VILLAGE OF GERMANTOWN
N112 W17001 MEQUON ROAD
GERMANTOWN, WI 53022

MEETING:	PLAN COMMISSION
DATE AND TIME:	MONDAY, JULY 23, 2018 6:30 p.m.
LOCATION:	Germantown Village Hall Board Room

7/23/18 Plan Commission Meeting

Village Planner Report

SHEET
C-10
C-22

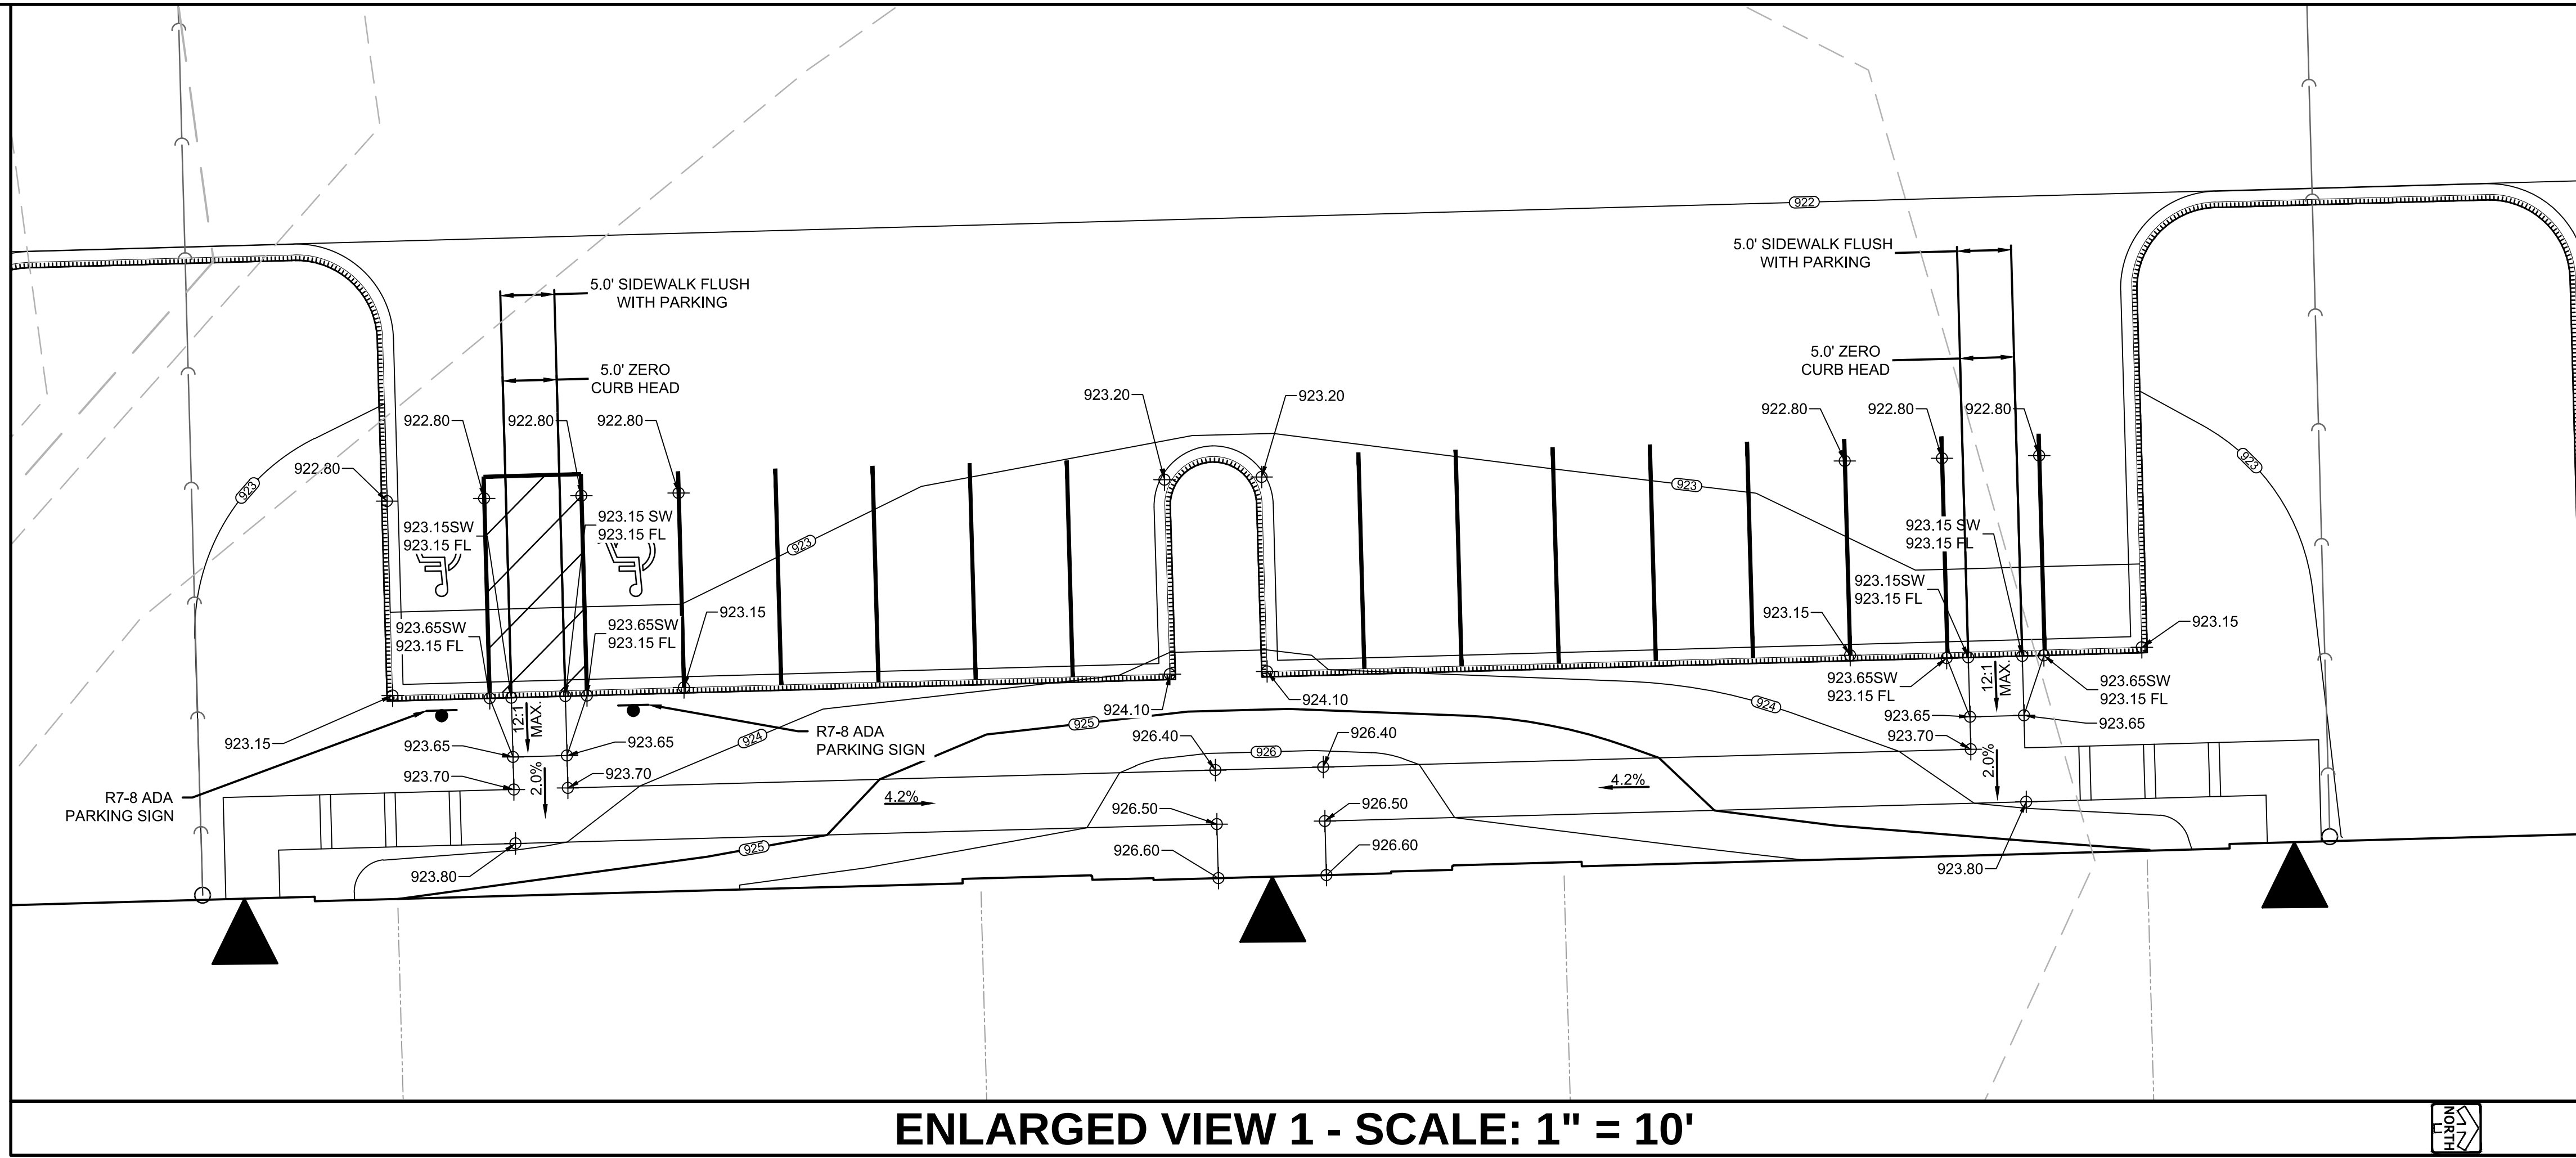
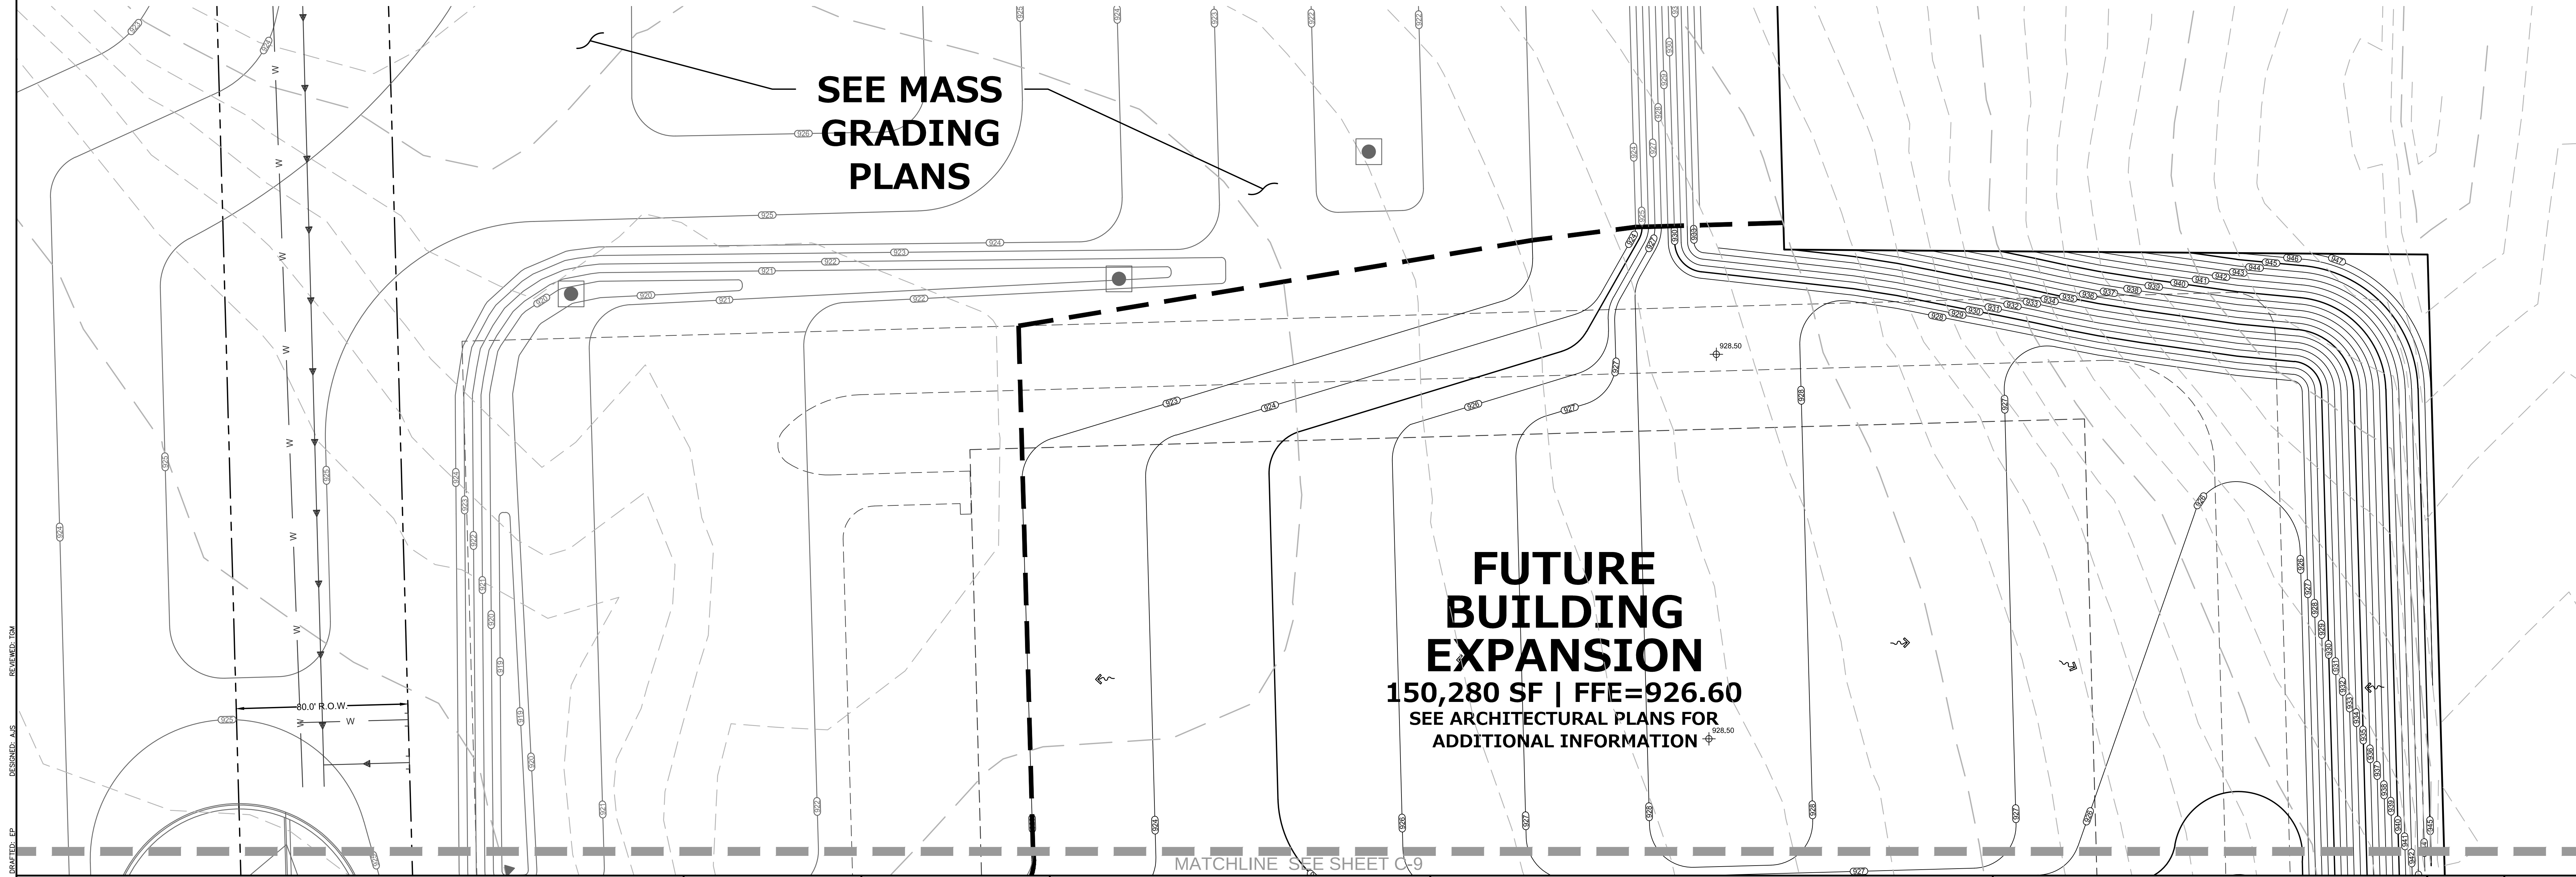
1. Enlarged view has no spot elevations, dimensions, or notes. Please revise to include those items.
The enlarged view has been updated with spot elevations, dimensions and notes. See sheet C-10

SHEET
C-13
C-22

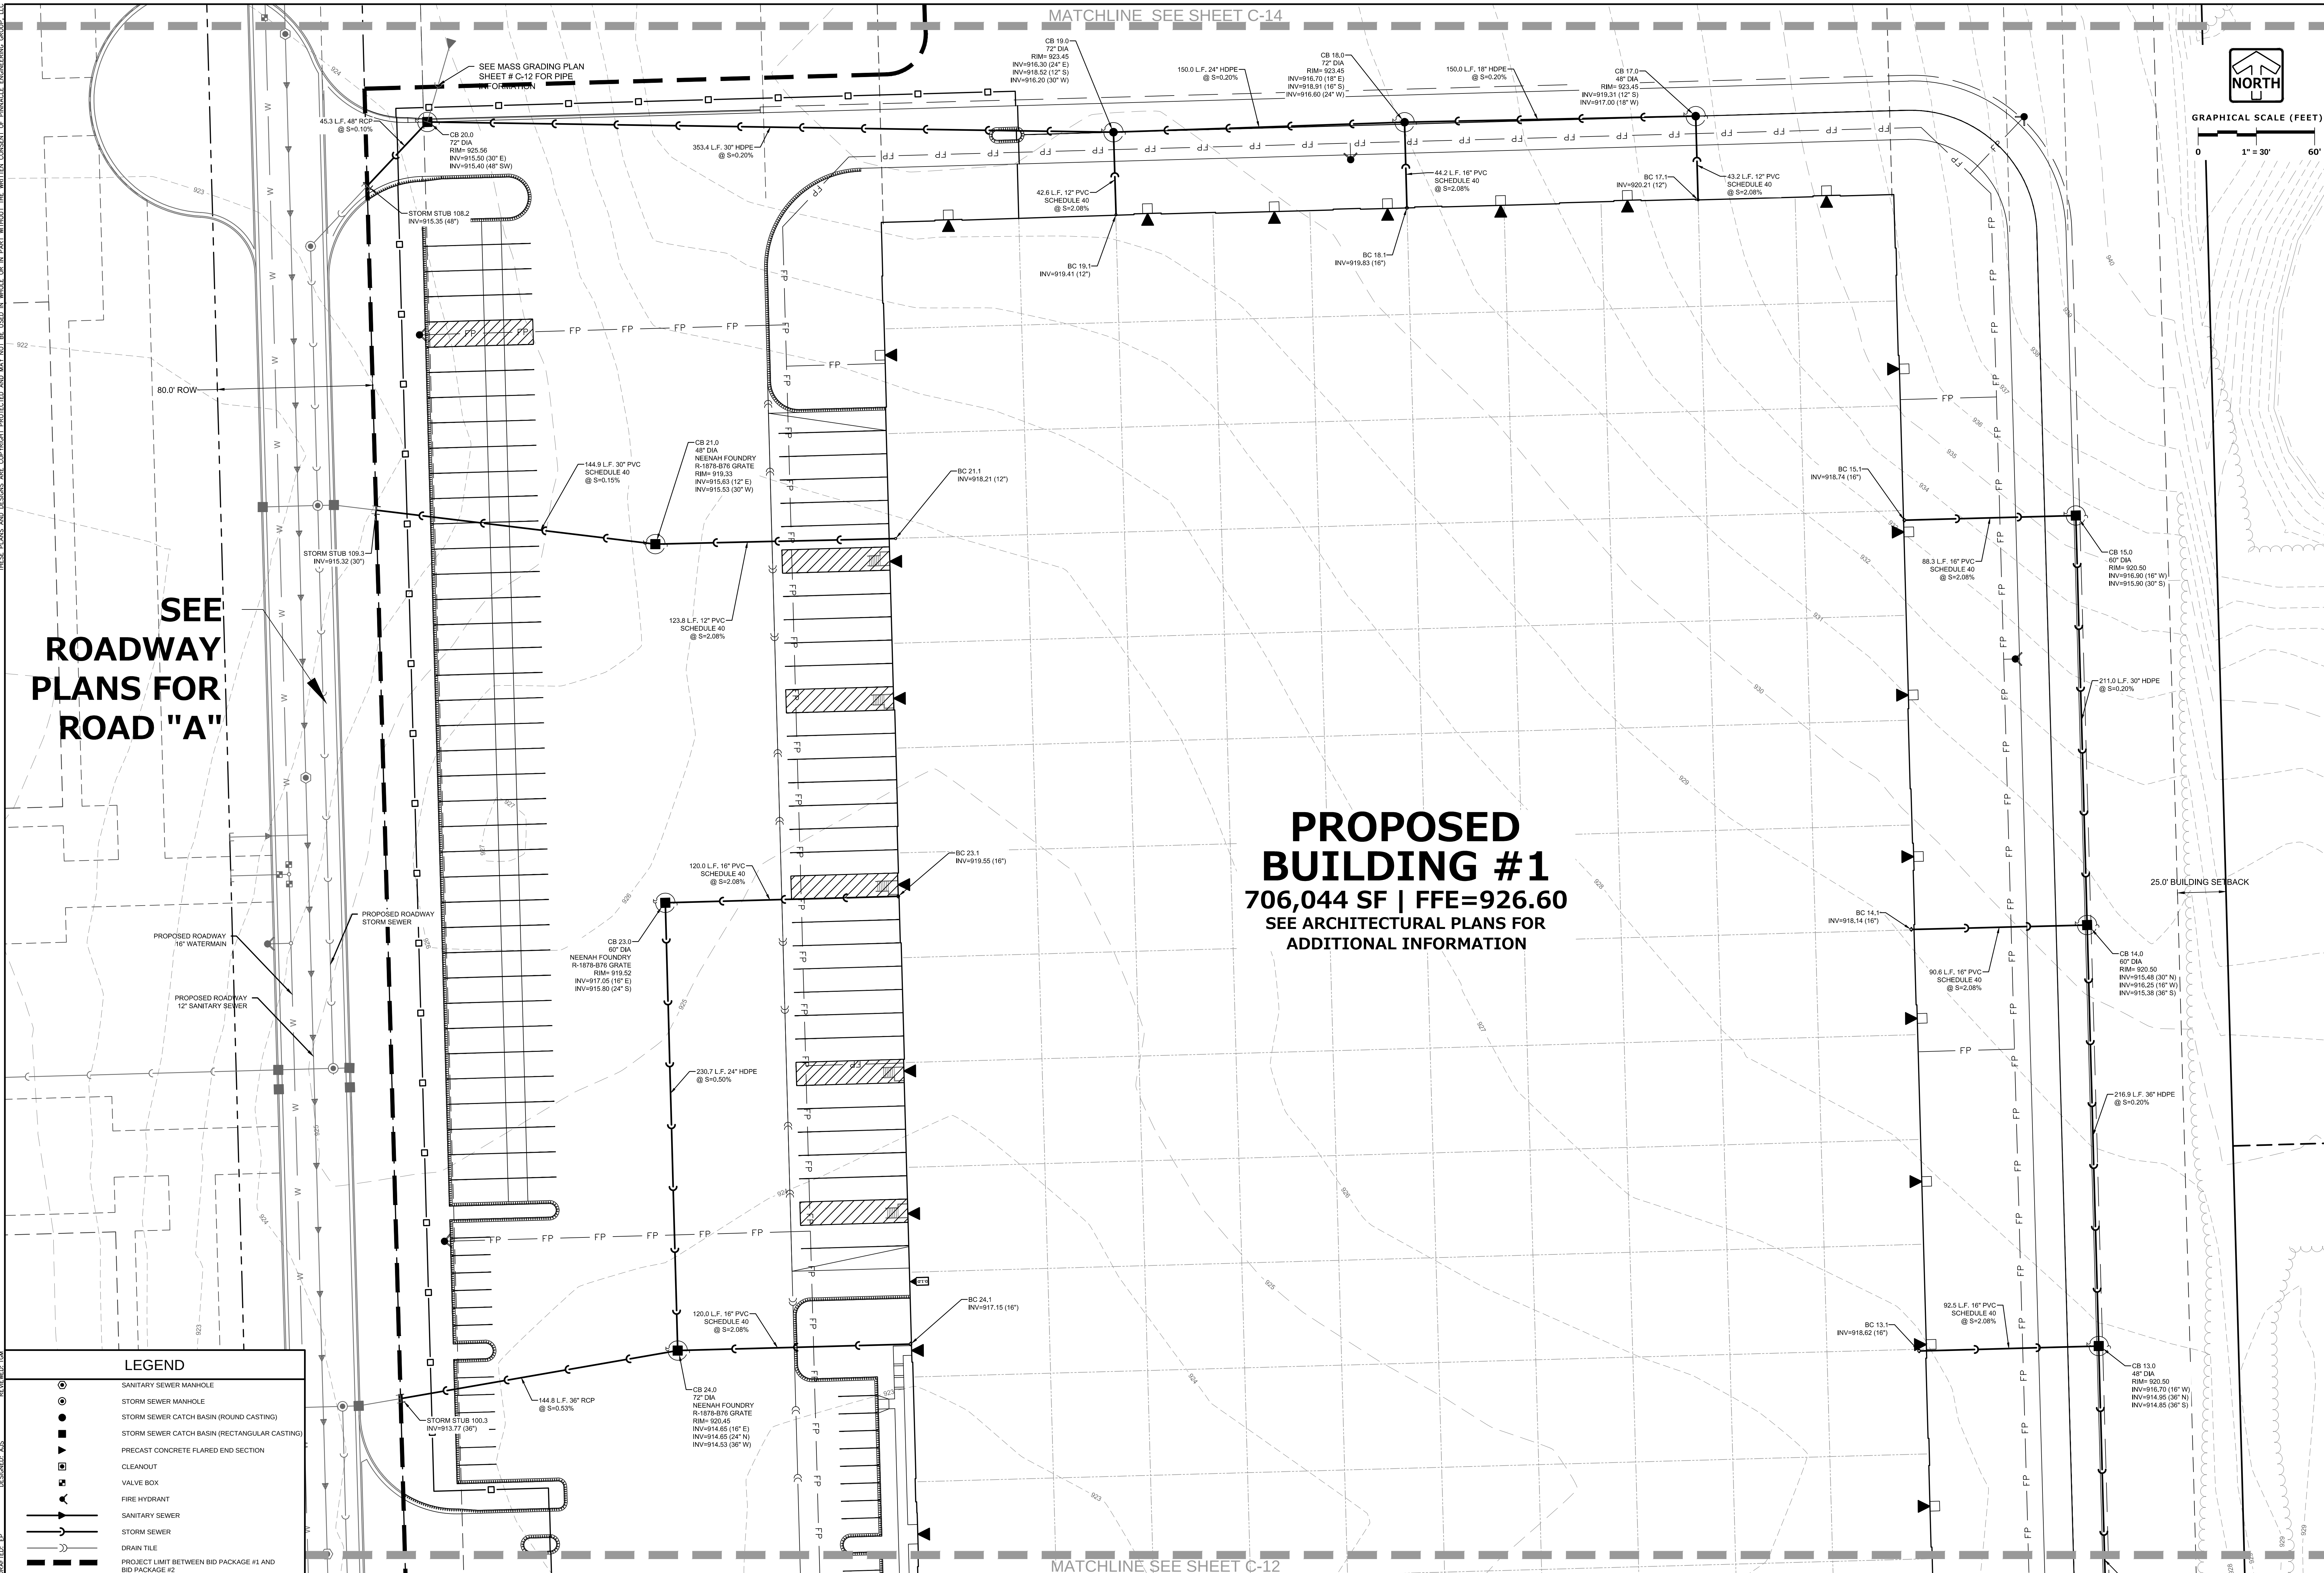
1. CB 16: 96" diameter seems excessive for a 10" and 24" pipe.
Please note that roof drain locations have changed. Manhole Sizes have been updated and CB 16 has changed to a 48" diameter manhole from a 96" diameter manhole based on updated roof leader sizing. See sheet C-13.

2. CB 17: 96" diameter seems excessive for an 18" and 12" pipe.
Please note that roof drain locations have changed. Manhole Sizes have been updated and CB 17 has changed to a 48" diameter manhole from a 96" diameter manhole. See sheet C-13.
